ADDENDUM No. 1

City of Austin

Project Name Future District Cooling Plant #3 Water, Sewer, and Temporary Power

C.I.P. No. 6685,033

**GENERAL PERMIT OFFICE
ELECTRICAL
SITE PLAN**

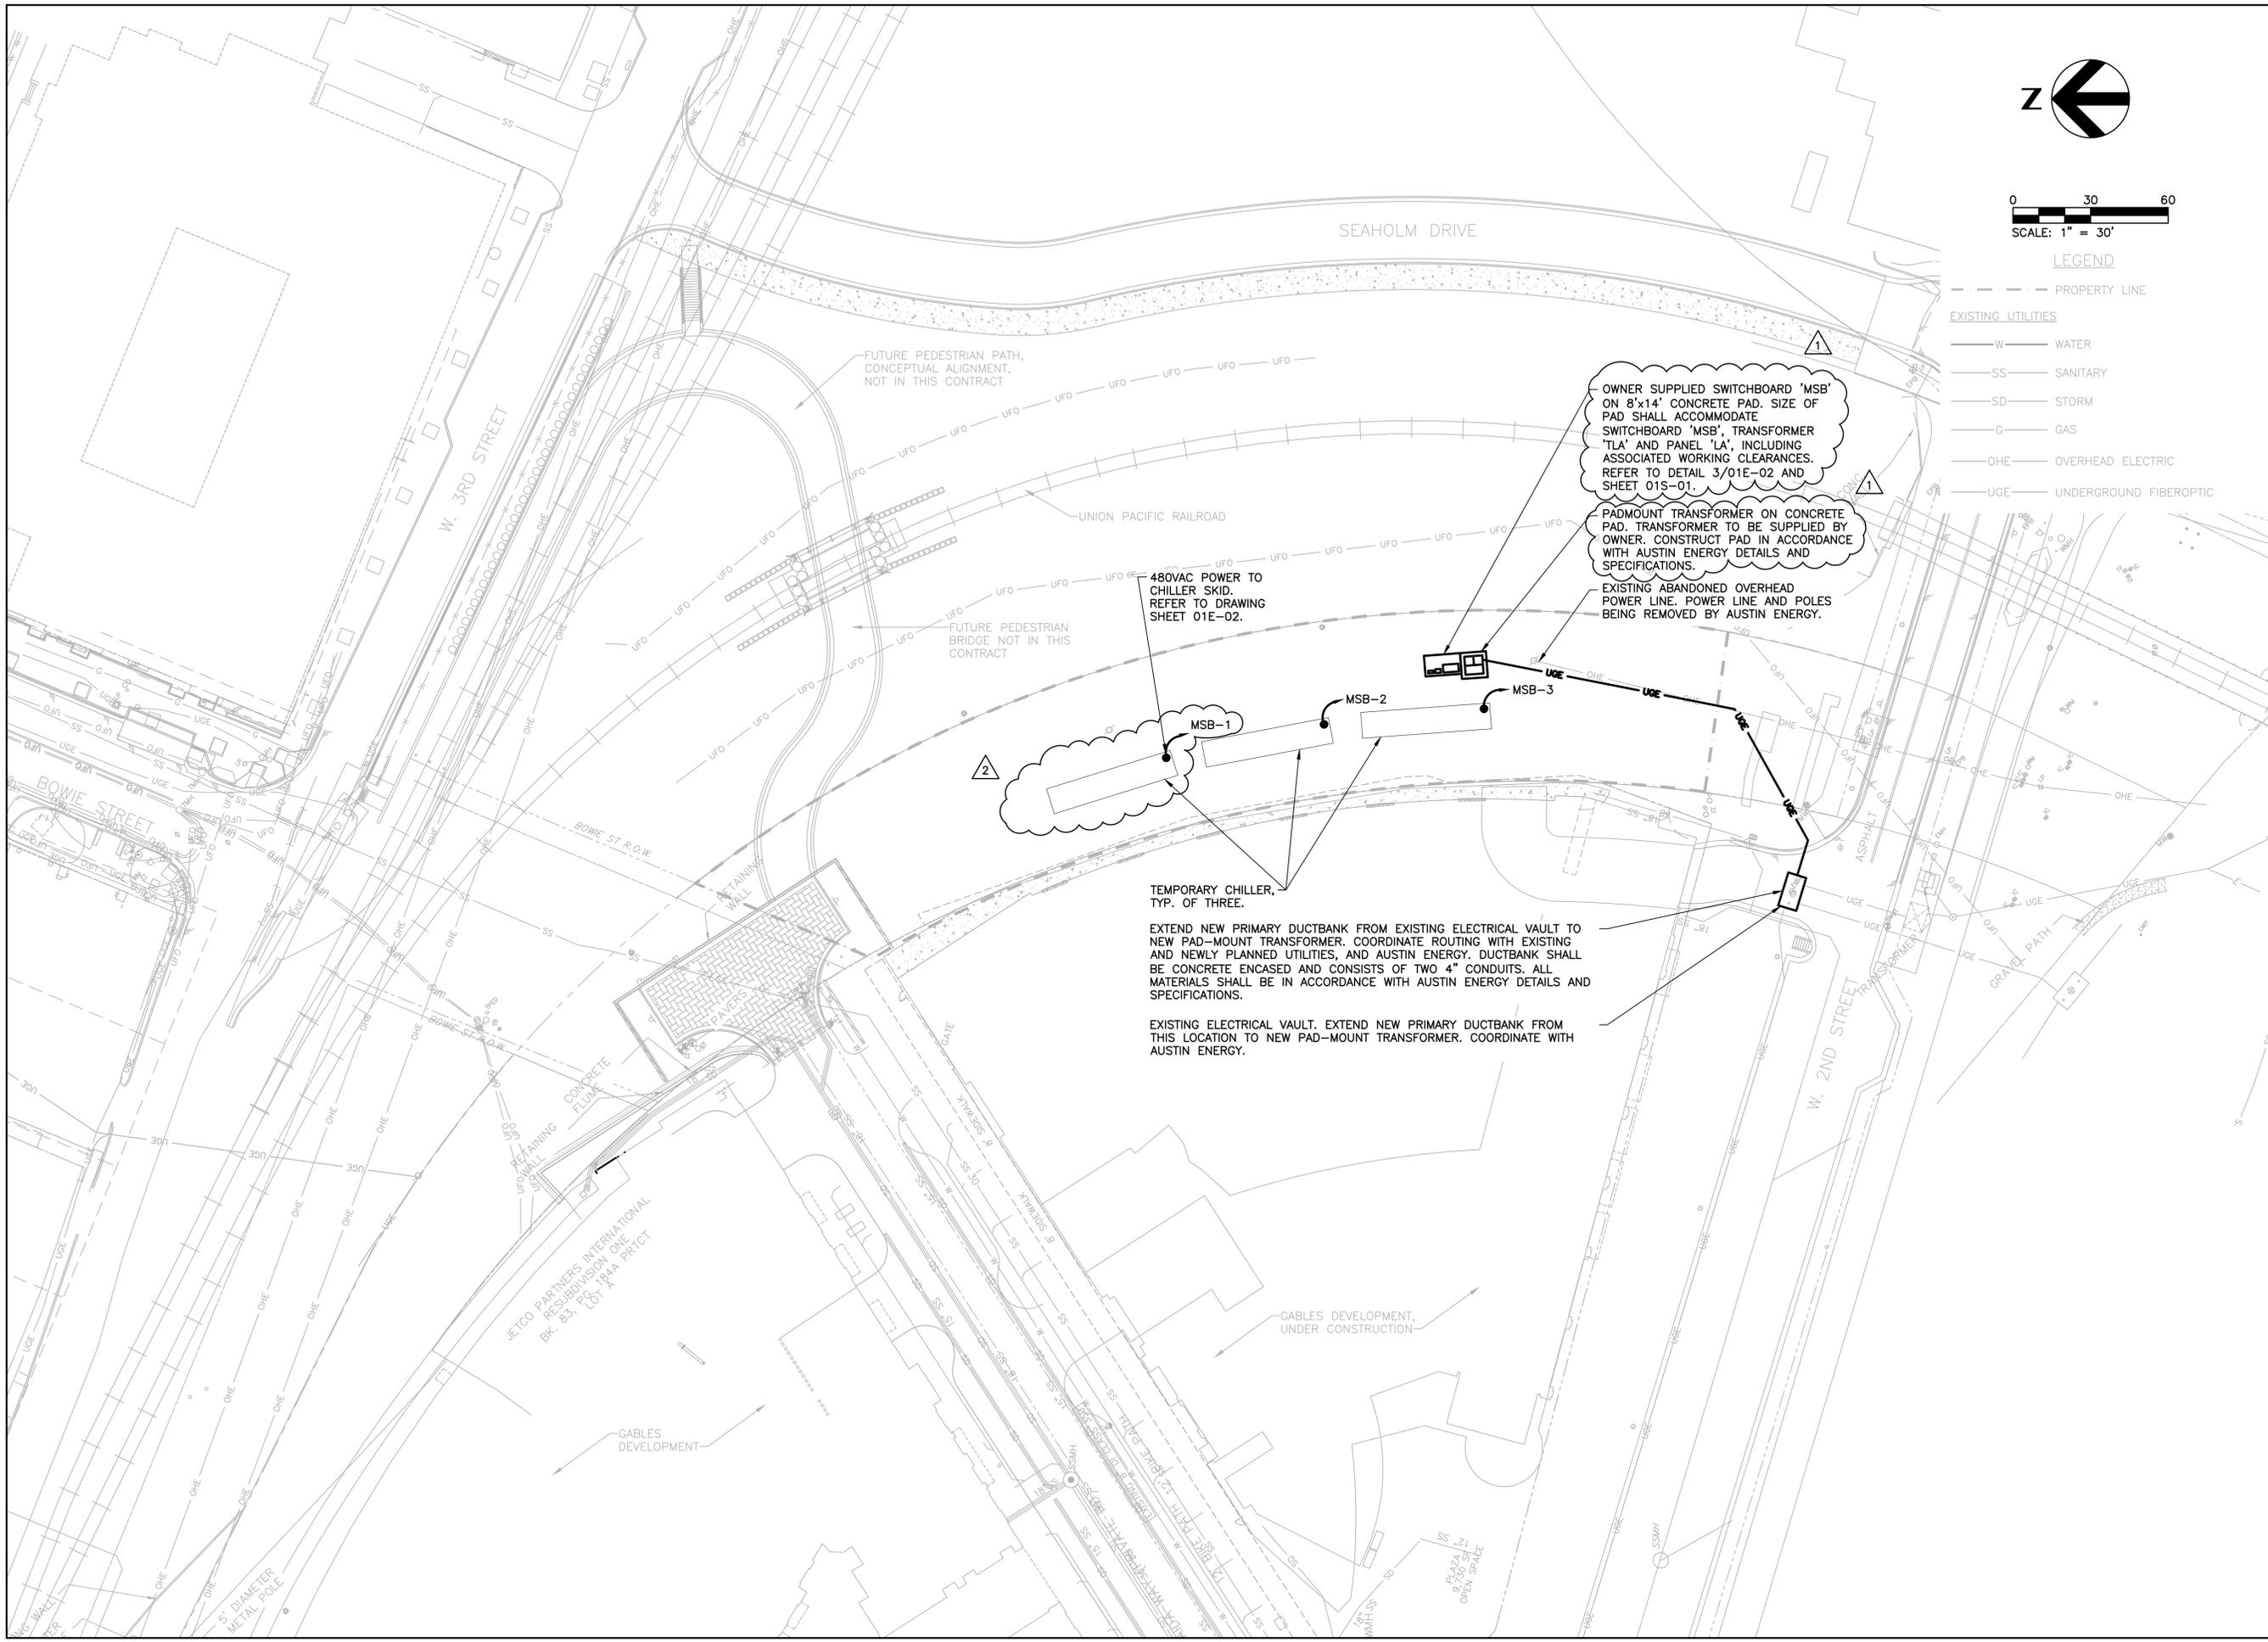
1. Delete Drawing 01E-01 and replaced with the attached Drawing 01E-01.
2. The temporary chiller location (chillers not in this contract) has been modified as shown on attached Drawing 01E-01. The temporary retaining wall (not in this contract) shown on Sheets 01C-01, 01C-02 and 01C-03 has been removed.

NO.	BY	DATE	REVISIONS	REMARKS
1	PD	8/30/13	ADDED OWNER SUPPLIED	
2	PD	8/30/13	RELOCATED THIRD TEMP CHILLER

OWNER SUPPLIED SWITCHBOARD 'MSB' ON 8'x14' CONCRETE PAD. SIZE OF PAD SHALL ACCOMMODATE SWITCHBOARD 'MSB', TRANSFORMER 'TLA' AND PANEL 'LA', INCLUDING ASSOCIATED WORKING CLEARANCES. REFER TO DETAIL 3/01E-02 AND SHEET 01S-01.

TEMPORARY CHILLER, TYP. OF THREE.
